Tritium is believed to moving to the north at ≈ 80 feet/year from the VB-2 (2000) well and at the same rate to the NNW from the VB-3 figure 1

SITE PLAN AND WELL LOCATIONS BRAIDWOOD STATION Braceville, Illinois

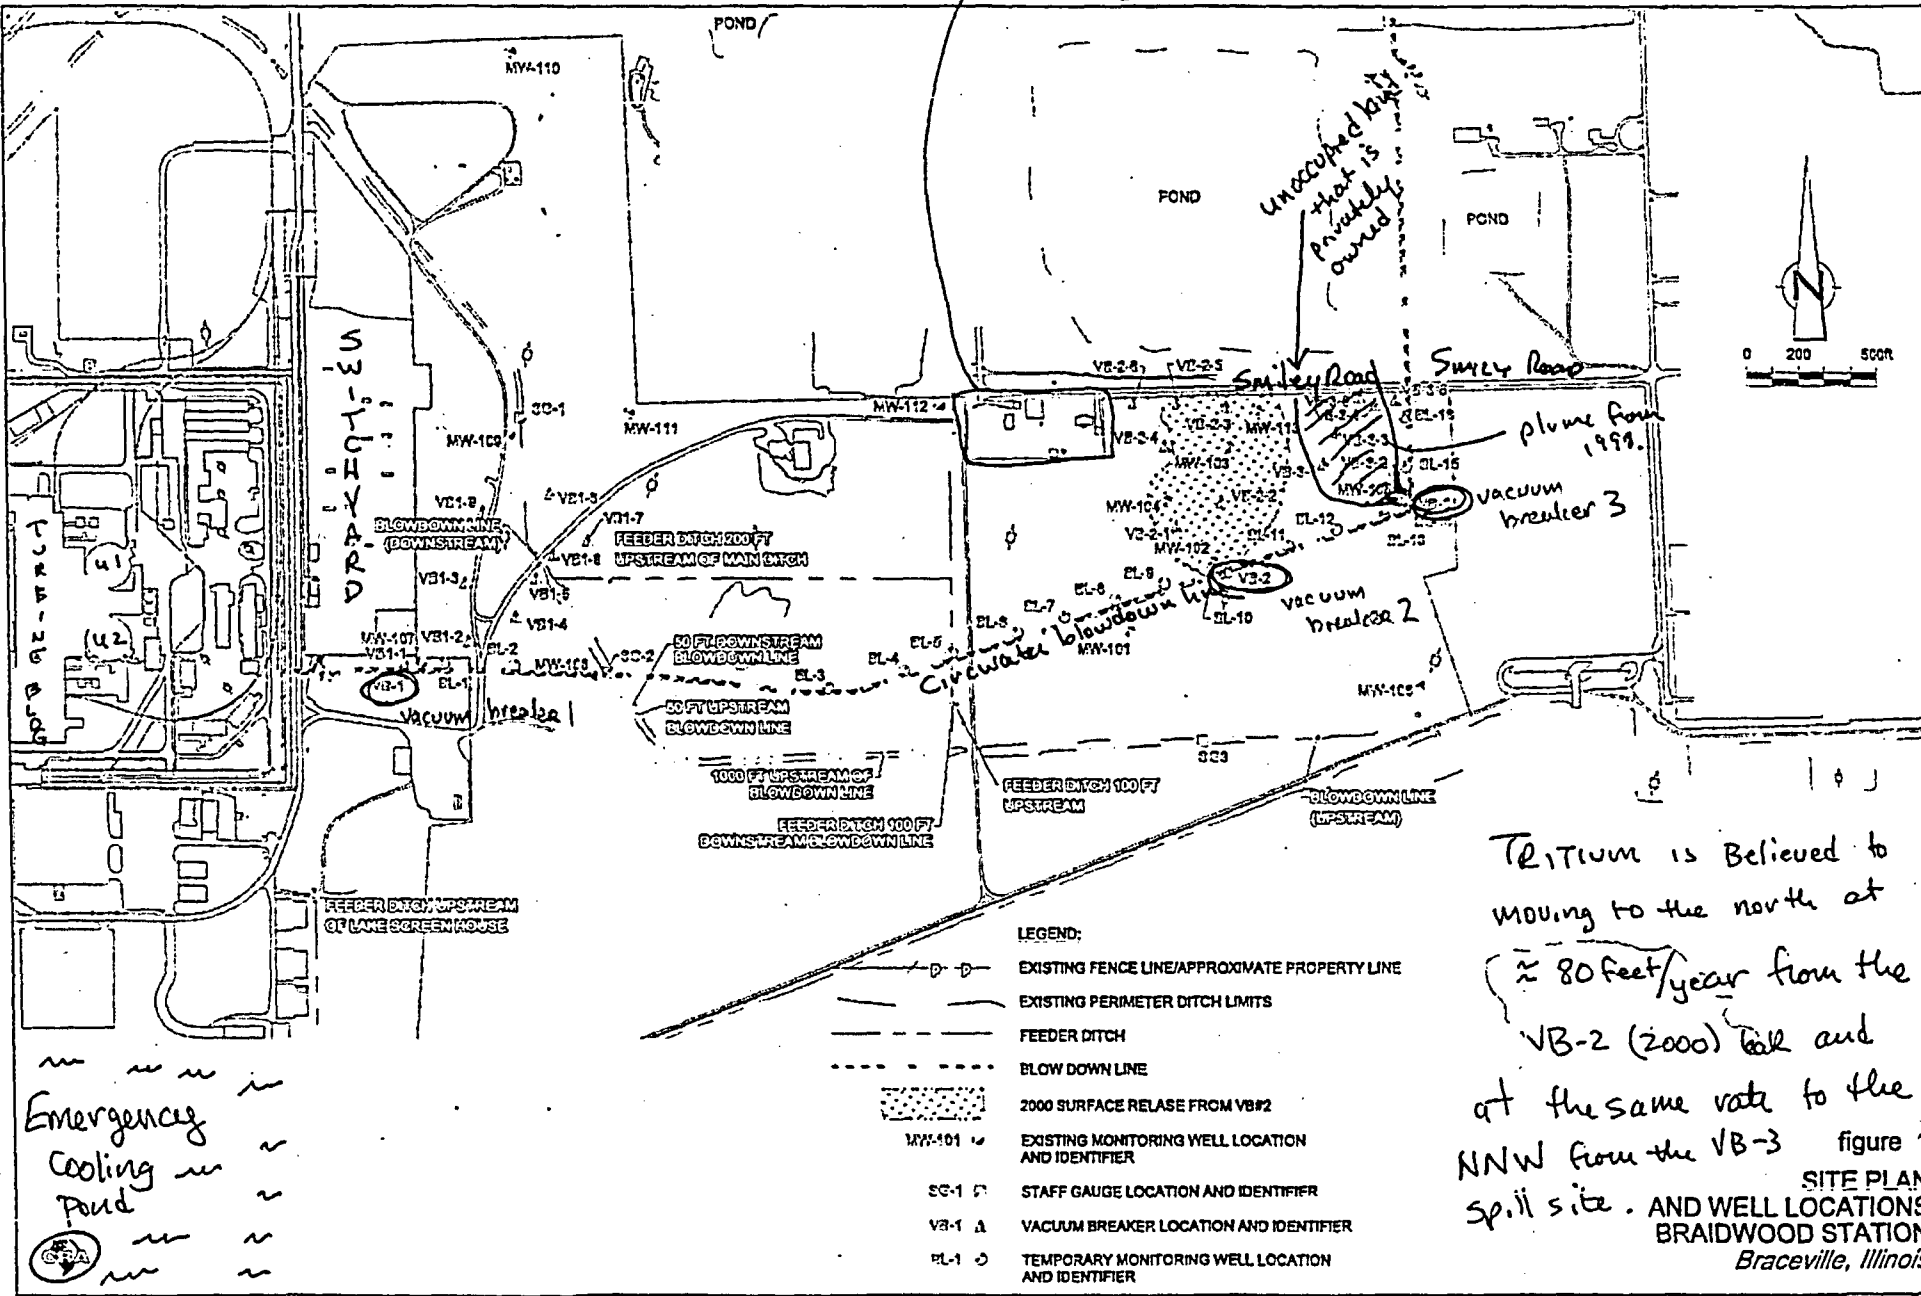
3 occupied homes, the licensee is inquiring about testing their drinking wells.

unoccupied lots that is privately owned

plume from 1999.
